Our Reference: 210642.1

**BUILDING CODE OF AUSTRALIA 2019 AMDT 1 REVIEW - FINAL**  
**Brookvale Swim School & Wellness Centre – 145 Old Pittwater Road, Brookvale.**

McCarthy Consulting Group Pty Ltd have undertaken a desktop review of the current drawings as referenced below for the proposed Brookvale swim school and wellness centre at the above address against the provisions of Building Code of Australia 2019 (Amendment 1).

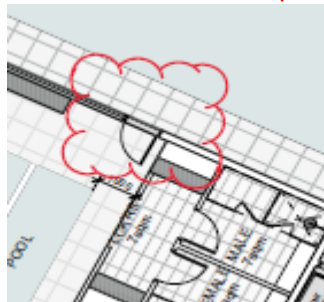
- Corridor width outside door leading from the main pool into the wellness centre to be confirmed. Minimum corridor width of 1450mm required,

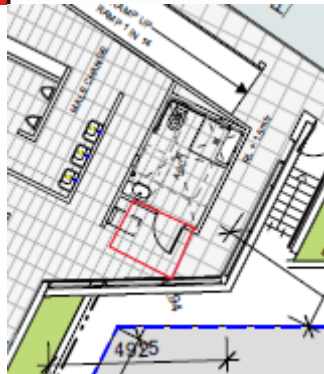
- The circulation space outside accessible toilet to be confirmed as compliant with AS1428.1 Figure 31(h)

- Circulation space to 'Steam-room' doorway to be confirmed – appears to be impacted by the adjacent pool,
